Austar Coal Mine Pty Ltd
A.B.N. 67 111 910 822

Response to Submissions - Modification to Longwall A5a Varied Commencing End

Five submissions were made during the comment period of the Modification Application for the Austar Coal Mine Proposed Longwall A5a Varied Commencing End (DA29/95 MOD 5). The issues raised in each submission are summarised below.

DRAWN G. MULHEARN		AUSTAR COAL MINE		YANCOAL AUSTRALIA PTY LTD	
REVISION DATE: 5/3/2012		TITLE FIGURE 1: EXTENT OF STAGE 2 MOD 5 and STAGE 3 MODIFICATION SUBSIDENCE AND MUXLOW PROPERTY			
CHECKED					
APPROVED		SCALE Refer Scale Bar	DRAWING No. Stage2Mod5_RTSubmissionsFig1		 AUSTAR COALMINE

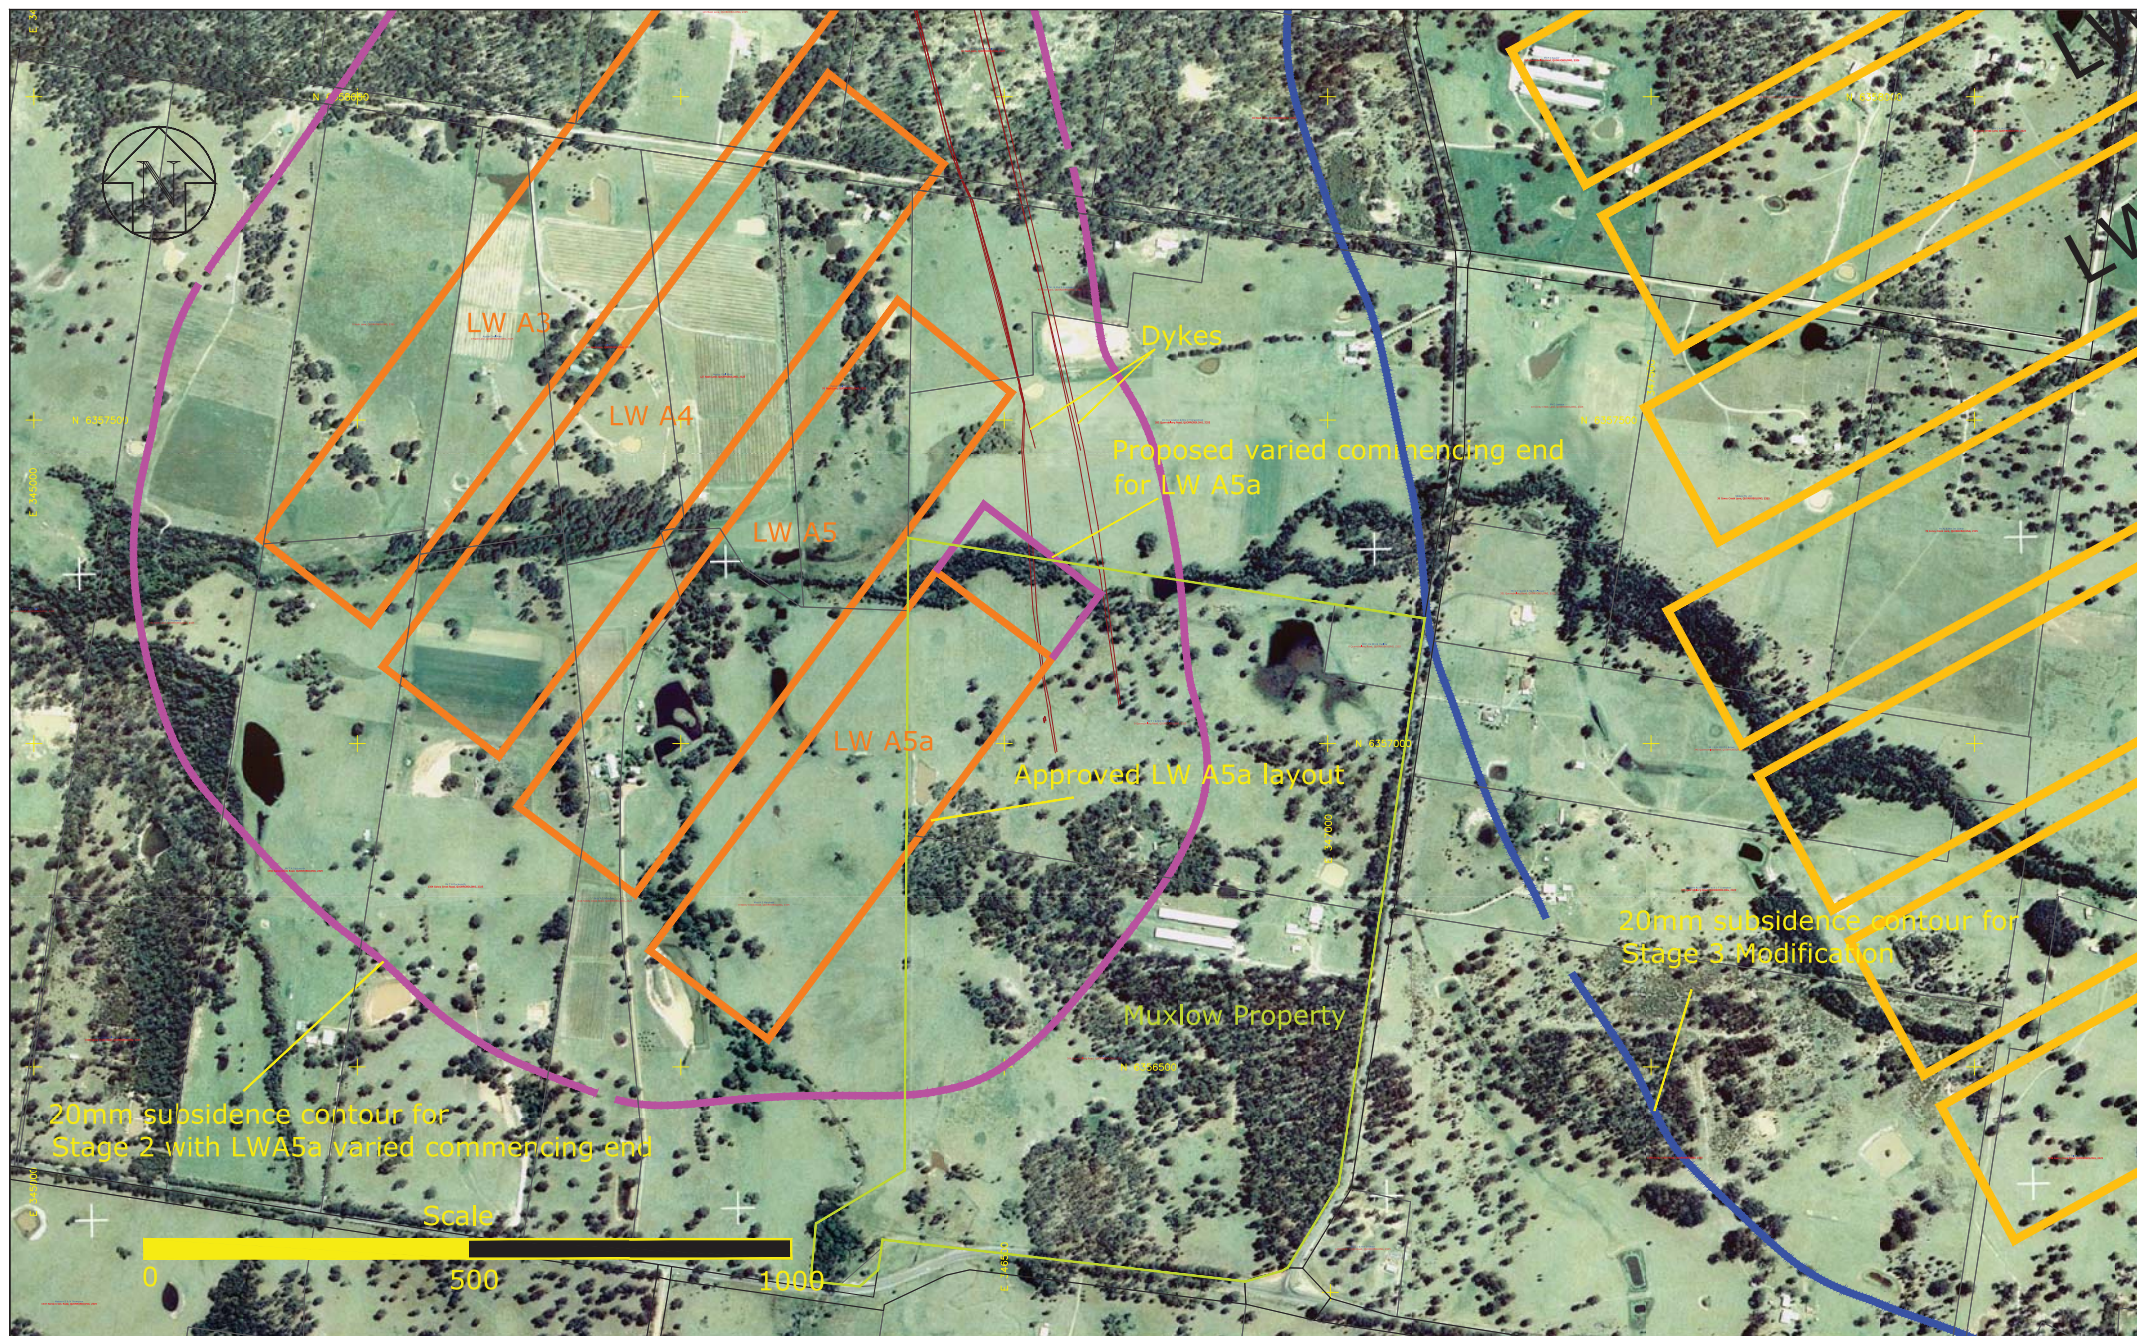
1. *"The EPA notes that new geological information with regards to dykes in the proposed footprint of Longwall Panel A5a has led to a change in the mine plan, and as a consequence an application to modify the existing consent. The presence of geological structures, such as dykes, can lead to non-conventional subsidence impacts to those predicted by modelling (Halla, 1987). In this case the significance of these dykes, as associated faults on any likely resulting mine subsidence for this proposal is not stated in the EA, and the EPA notes that none of the plans or cross-sections in the EA show any geological structures that may identify areas on the surface where non-conventional subsidence events could occur."*

2. *"The value of the property as a poultry farm has all but gone....This extra new area proposed in (DA29/95 MOD5) to be mined under our property will certainly stop even the slightest chance of ever a poultry farmer entertaining the idea of purchasing the property. Even selling for hobby farming uses at greatly reduced value will certainly be a very hard proposition."*

The location of dykes in relation to the proposed A5a varied commencing end is shown in **Figure 1**. Due to the western dyke being relatively small in nature and not associated with any major faulting no zones of increased subsidence risk have been identified.

The Muxlow dwelling and poultry sheds are outside the predicted 20mm subsidence contour for the approved Stage 2 mine plan, the proposed Longwall A5a varied commencing end mine plan, and the

proposed Stage 3 modification mine plan (refer **Figure 1**). The mining operation therefore has not affected the operation of the poultry sheds to date, and also predicted subsidence from underground mining should not affect operation of the sheds in future (should the Stage 3 modification be approved).

FIGURE 2: GROUNDWATER MONITORING BORES INCLUDING NEW ALLUVIAL MONITORING BORES (WBH1 TO WBH3)

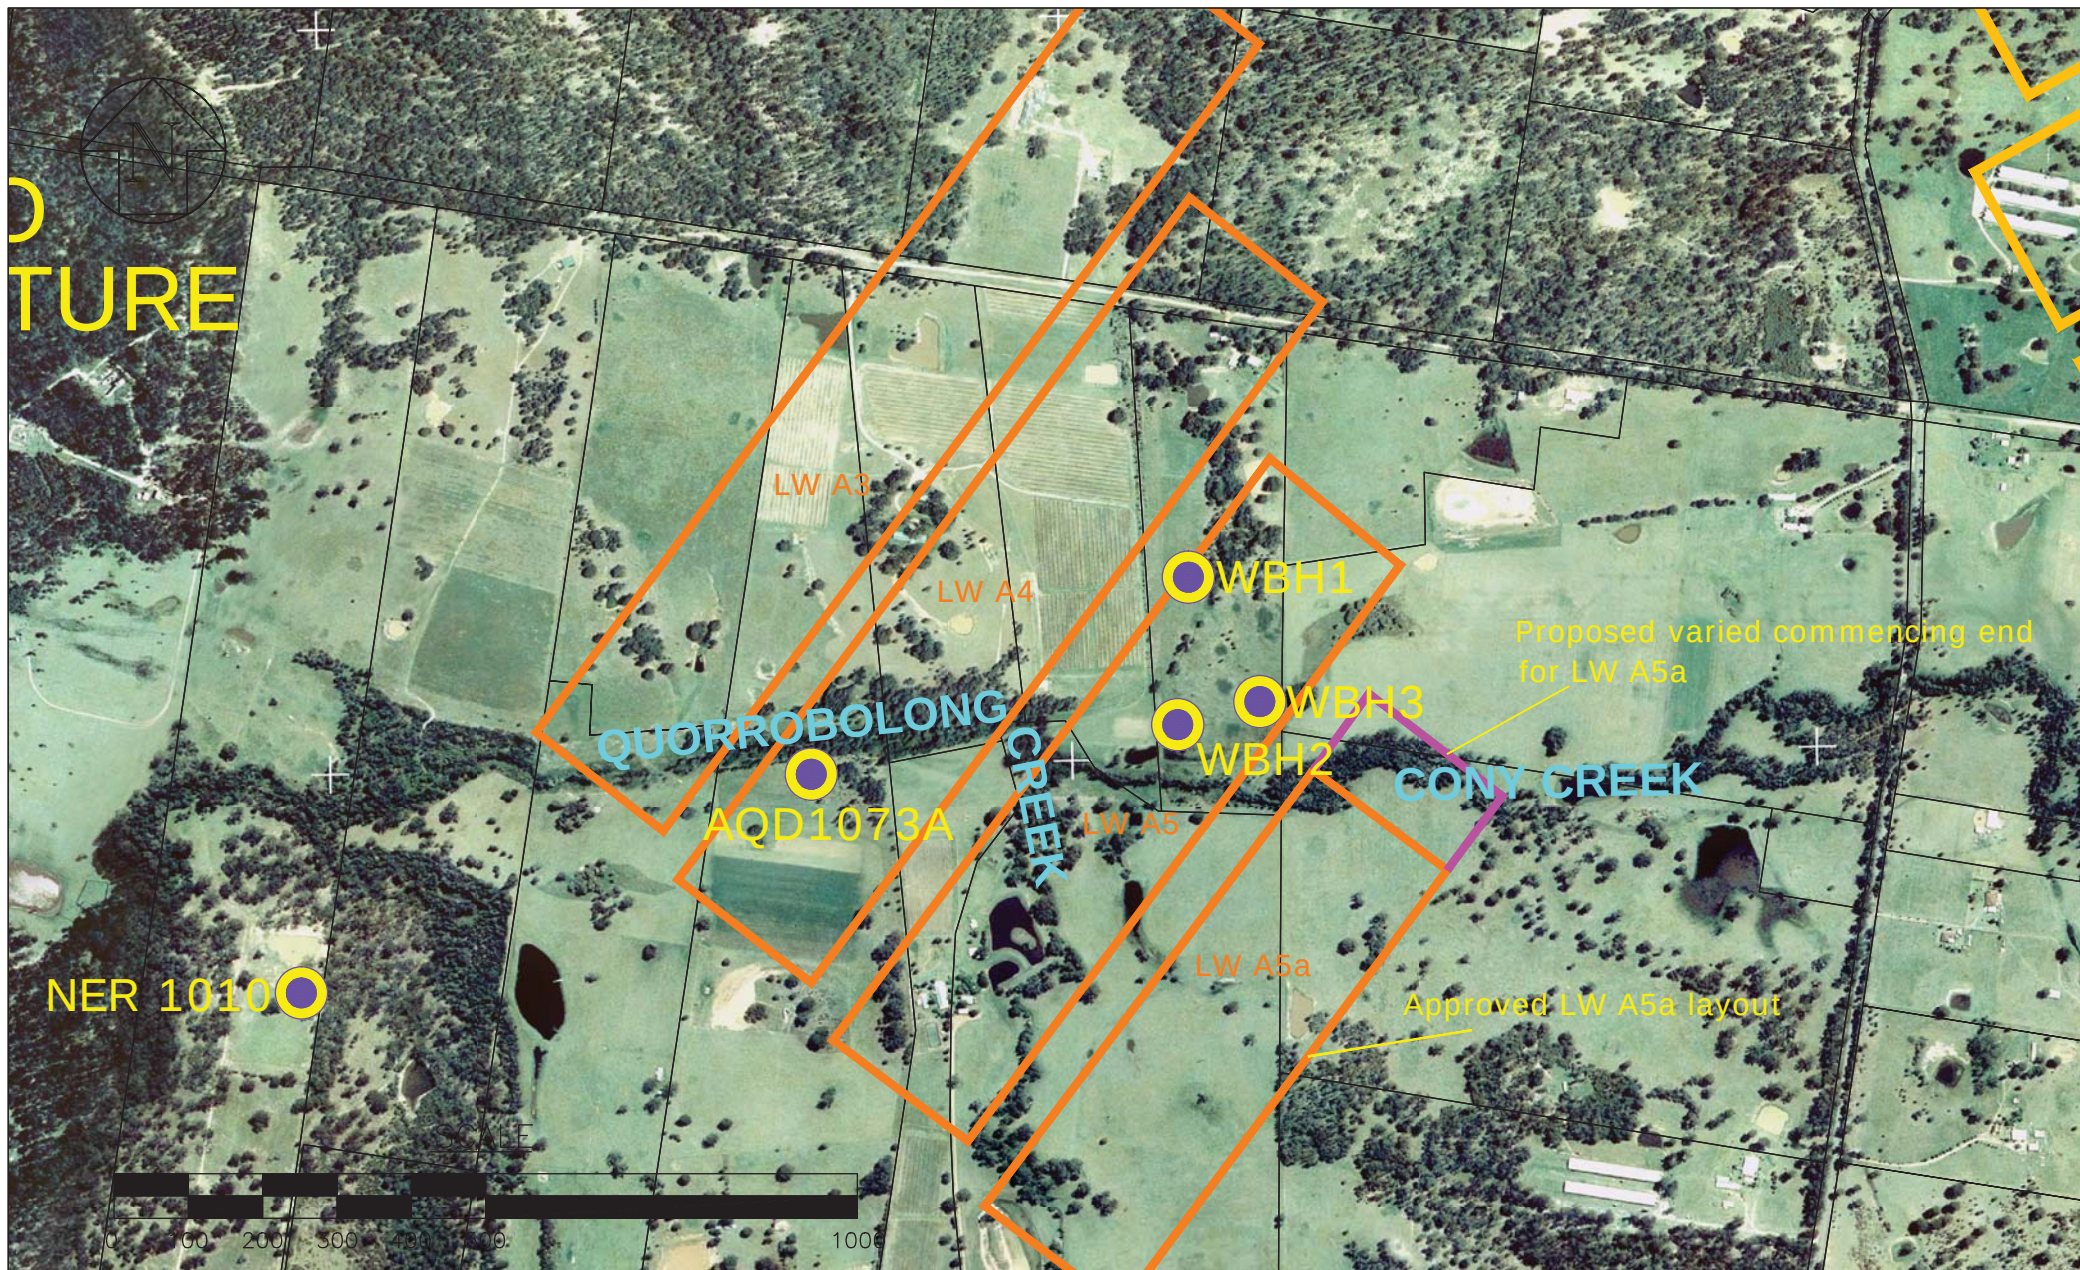
2. The NSW Office of Water outlined monitoring and management recommendations which are recommended for inclusion in Austar's project approval relating to surface water and groundwater. The recommendations for monitoring and management of Quorrobolong and Cony Creeks – Longwalls A3 to A5a were included as Attachment A.

In consultation with NOW ahead of the Longwall A5a modification approval in 2010, Austar discussed an extension to the alluvial groundwater monitoring program with locations to allow monitoring and analysis of lateral alluvial movements in the Stage 2 area. These alluvial monitoring bores were installed and licenced with NOW in July 2011. Results of monitoring and trend analysis from these and existing bores will be provided to NOW in subsequent Annual Environmental Management Reports. The location of the additional alluvial groundwater bores are shown in **Figure 2**.
